SUBJECT: Forwards response to SA Varga 820730, 0916 & 830810 requests
 for addl info re hydrogen combustion & control during
 degraded core accidents.

Donald C. Cook Nuclear Plant Unit Nos. 1 and 2
Docket Nos. 50-315 and 50-316
License Nos. DPR-58 and DPR-74
RESPONSES TO REQUESTS FOR INFORMATION ON
HYDROGEN COMBUSTION AND CONTROL

ATTACHMENT 1 TO AEP:NRC:0500K
HYDROGEN CONTROL QUESTIONS CHECKLIST
DONALD C. COOK NUCLEAR PLANT UNIT NOS. 1 AND 2

ATTACHMENT 3 TO AEP:NRC:0500K
RESPONSES TO QUESTIONS ON HYDROGEN CONTROL CONTAINED IN
MR. S. A. VARGA'S 16 SEPTEMBER 1982 LETTER
DONALD C. COOK NUCLEAR PLANT UNIT NOS. 1 AND 2

Figure 3-9

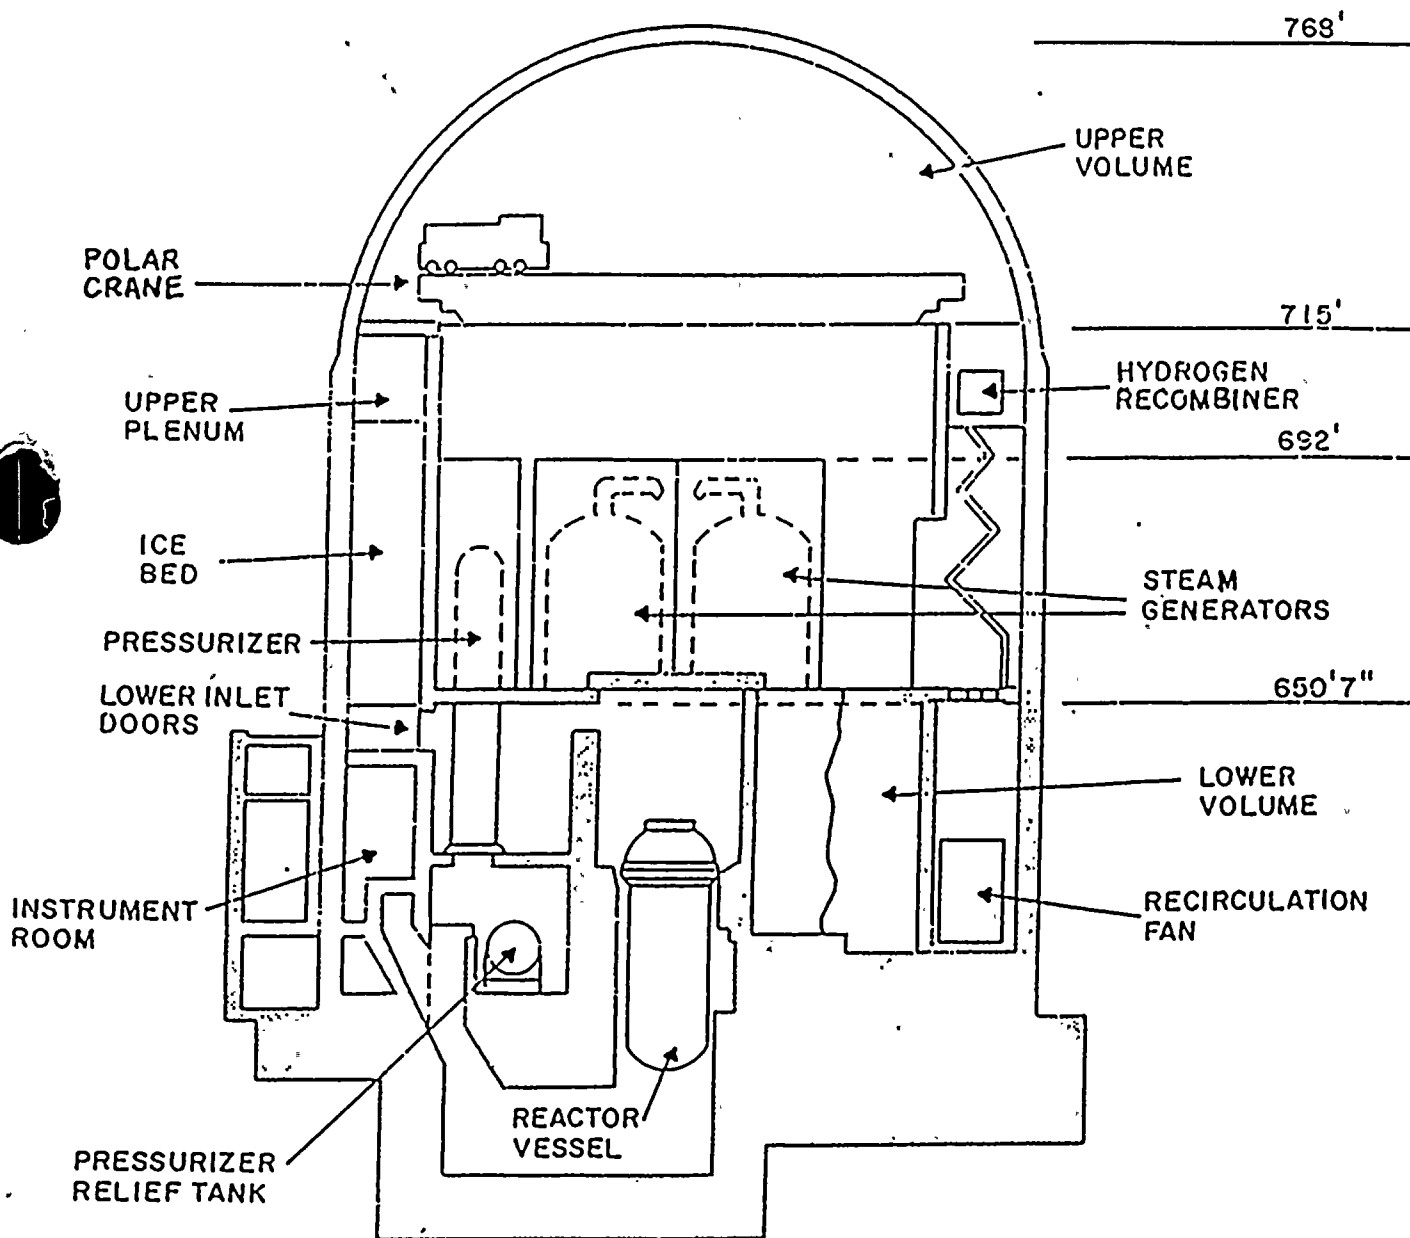
Provide details regarding the number and location of permanent igniters in containment. Discuss the influence of considerations such as volume served per igniter, and preferred flame direction on the design of the permanent system.

Table 3-7 provides a listing of GMAC glow plug locations in the Donald C. Cook Nuclear Plant Unit No. 2. These locations are typical for Unit No. 1. Figure 3-9 provides an overview of the Donald C. Cook Nuclear Plant ice condenser containment. Sectional drawings of the containment are also included as Figures 3-10 through 3-12, and identify the relative locations of the Train "A" and Train "B" igniters at each elevation.

At the present time, there are seventy GMAC glow plugs in each Unit of the Donald C. Cook Nuclear Plant (thirty-five igniters per train). Basic considerations in the design of the permanent hydrogen control system (Distributed Ignition System (DIS)) included coverage of likely hydrogen release points, coverage of areas of potential hydrogen accumulation, and proximity to safety related components. The reasons for installation of igniters in the Instrument Room have previously been reported in Attachment 1 to Reference (3.4). The volume served per igniter has not been a relevant consideration for the Donald C. Cook Nuclear Plant DIS design.
